Re: **Dune Stabilization  
Shelter Cover  
Florence, Oregon**

**Project 203.081**

## **Addendum #1 (Technical Memorandum)**

**Re:** Shelter Cove

FIGURE NO.  
6  
(MODIFIED)

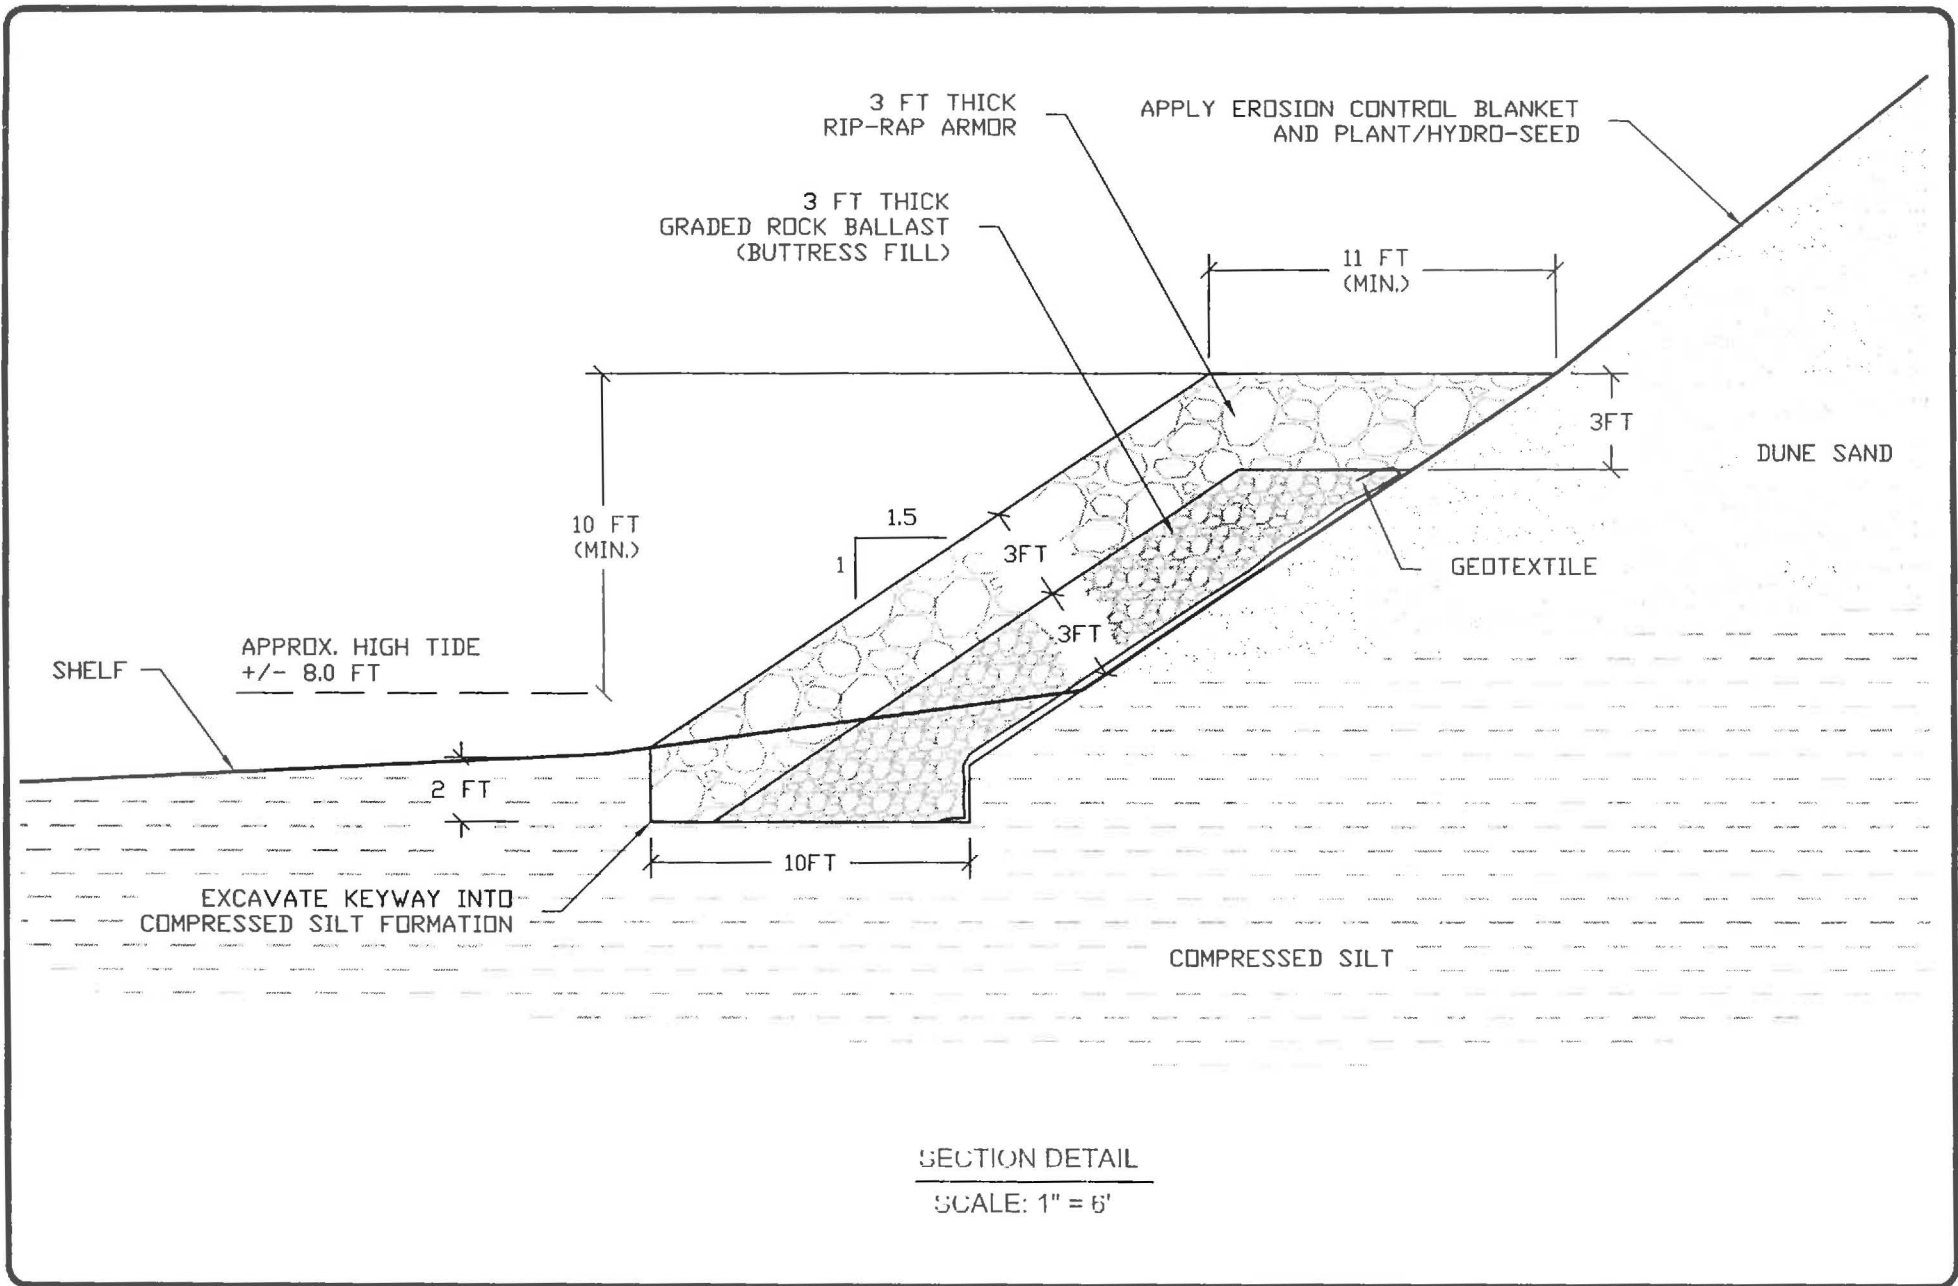
The revetment section has been reduced to a minimum, uniform width as shown on Figure 6 (Modified). We have not provided a plan drawing; however, the modified revetment would run the full length of the project area previously identified. The rock fill and riprap should cross over the intermediate sand ridges, which would require removing the soil overburden in these areas to expose the underlying layer of compressed silt. The compressed silt should then be benched and/or terraced to provide a keyway for rock fill and riprap placement. After completion of the work, there should be no discontinuities in the revetment along the full length. Revised material quantities are as follows:

Graded Rock Ballast:	1,400 cubic yards
Riprap:	2,250 cubic yards
